V2_Construction Drawings_COMMENTS.pdf Markup Summary

SPROUL JUNIOR HIGH SCHOOL

UTILITY CONSTRUCTION PLANS

UCV1

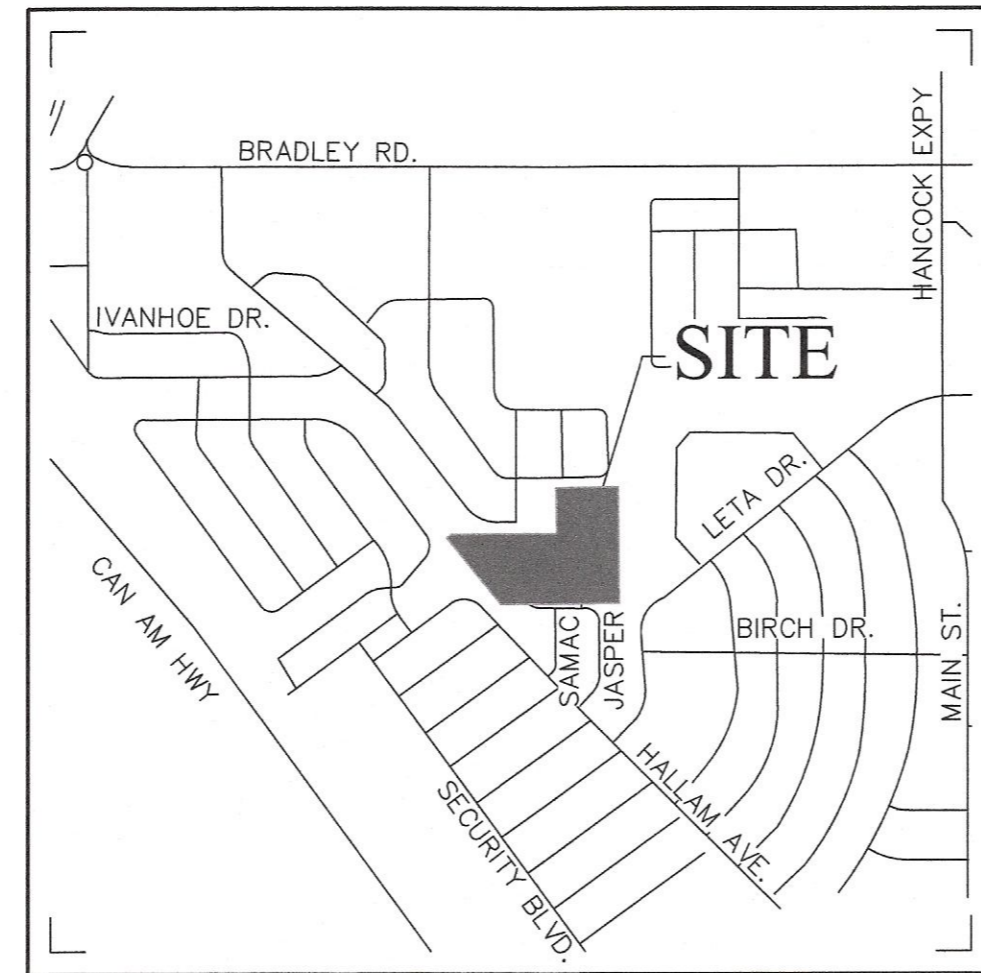
Unresolved review 1 comment:
All sheets of the CD's must be sealed, signed and dated.

SS01

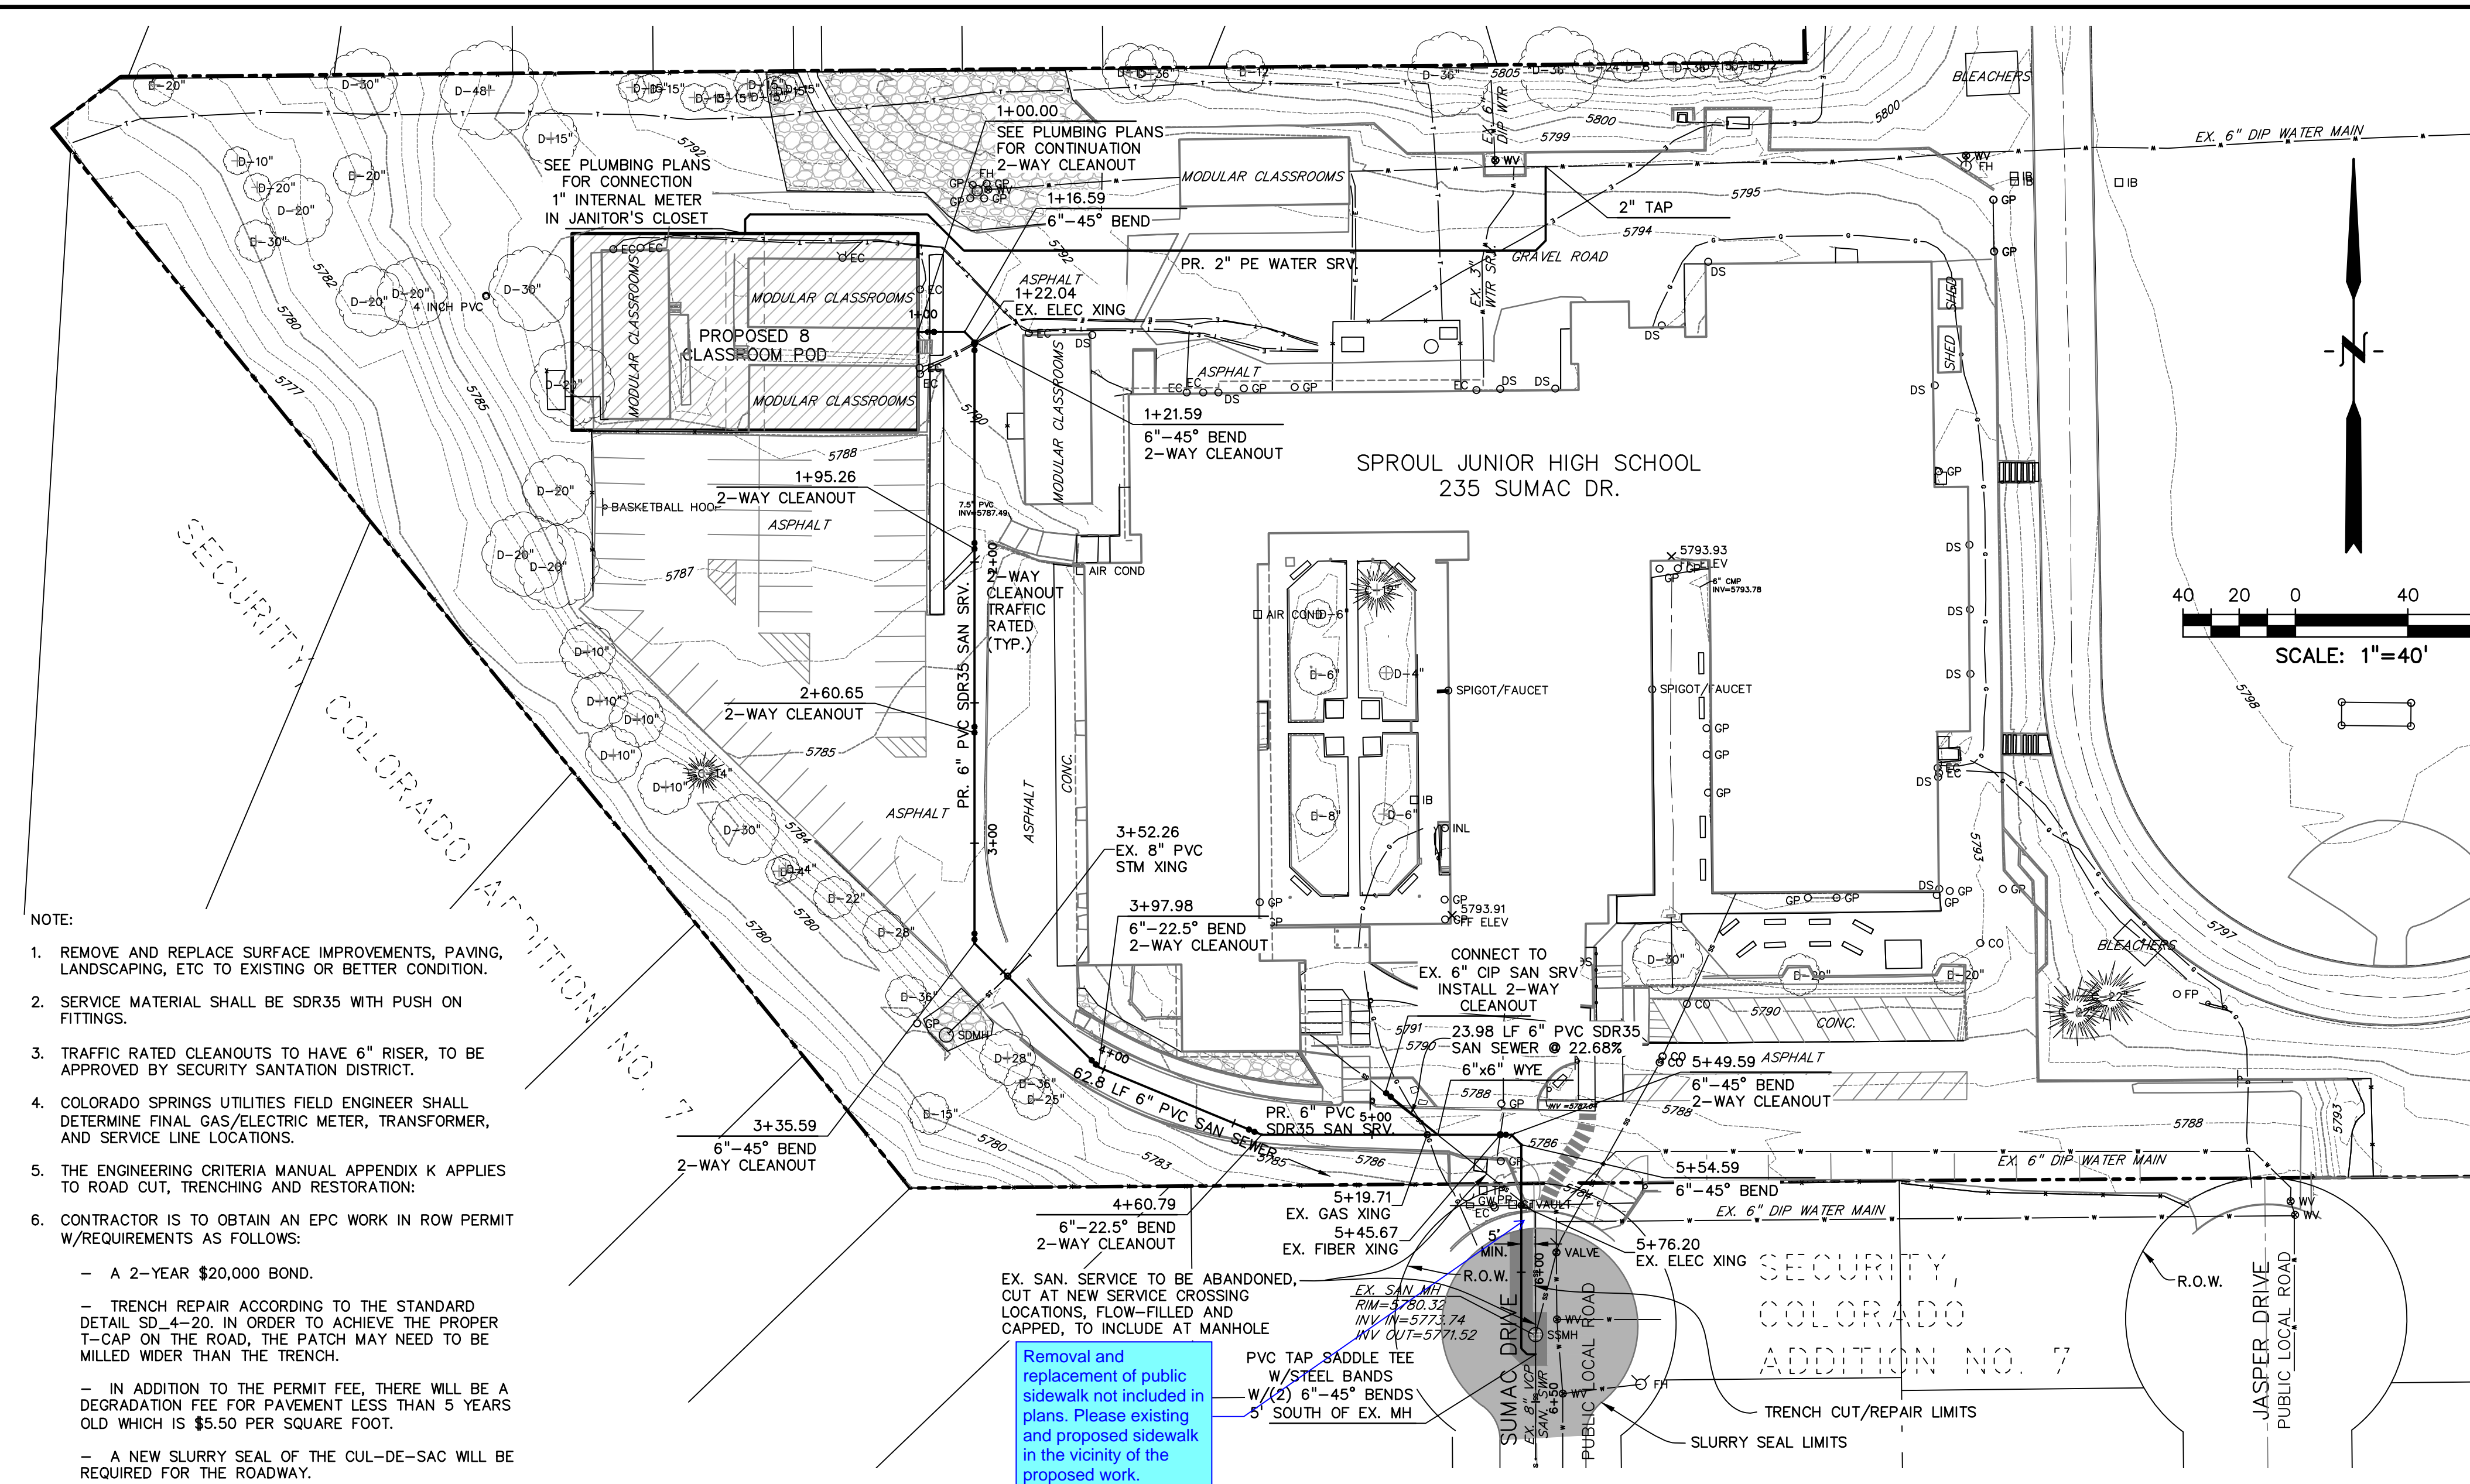
Removal and replacement of public sidewalk not included in plans. Please existing and proposed sidewalk in the vicinity of the proposed work.

Move EPC Signature Block to cover sheet of plans.
Design Engineer Statement and Owner/Developer statement was omitted and must be included, signed, and sealed.

Please add Trenching Detail Notes from Section K.2 of Appendix K in the ECM to construction plans.
